Austin Light Rail Phase 1

Final Environmental Impact Statement

Appendix K: Agency Coordination

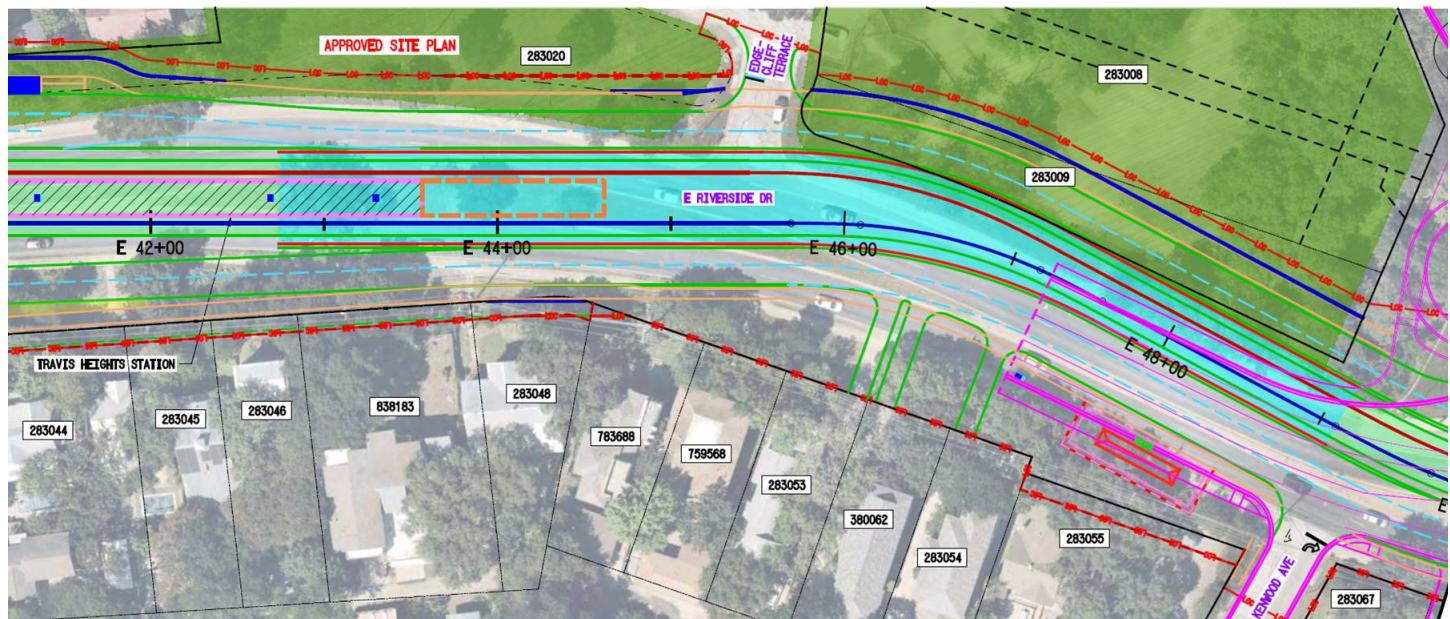
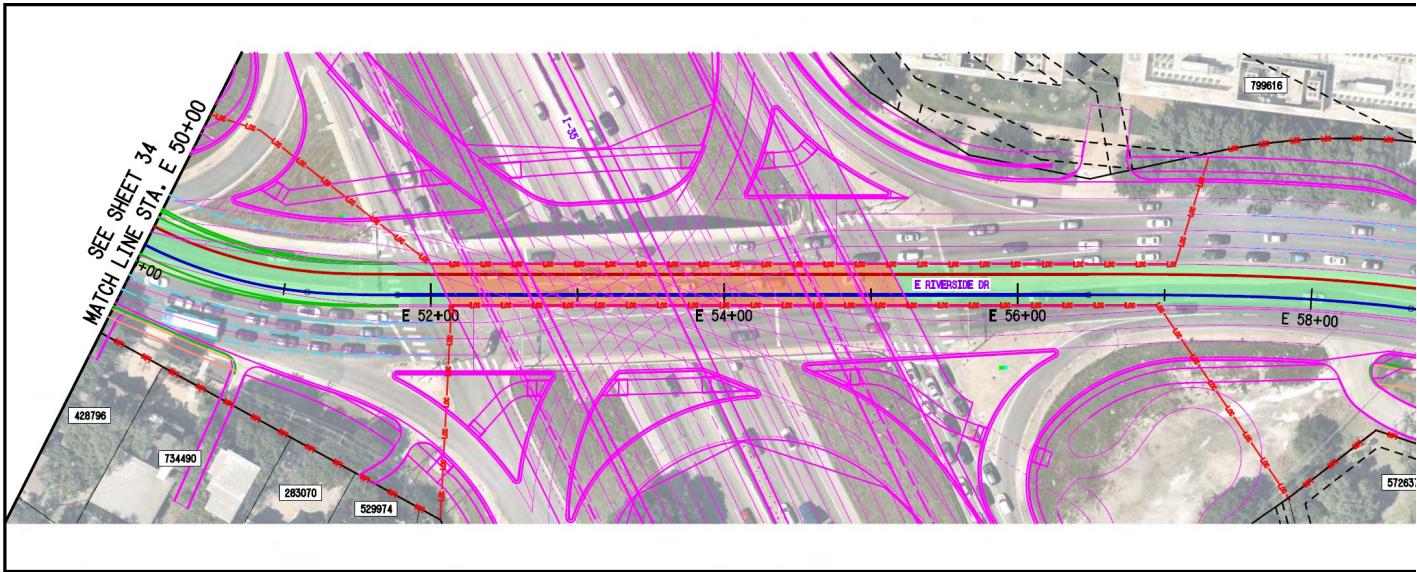
Sht 34-124 at the NW corner of Riverside and I35. At COA Watershed request we made a small modification to the storm drain system to accommodate future water quality treatment out of the ROW. I don't know if these was specifically for the Light Rail project. See attached email thread and pdf.

Also, confirmed the pink linework matches the latest CapEx-C LBL let plans (see snapshots below from the provided PDF, proposed work by others - CapEx-C LBL project), thanks.
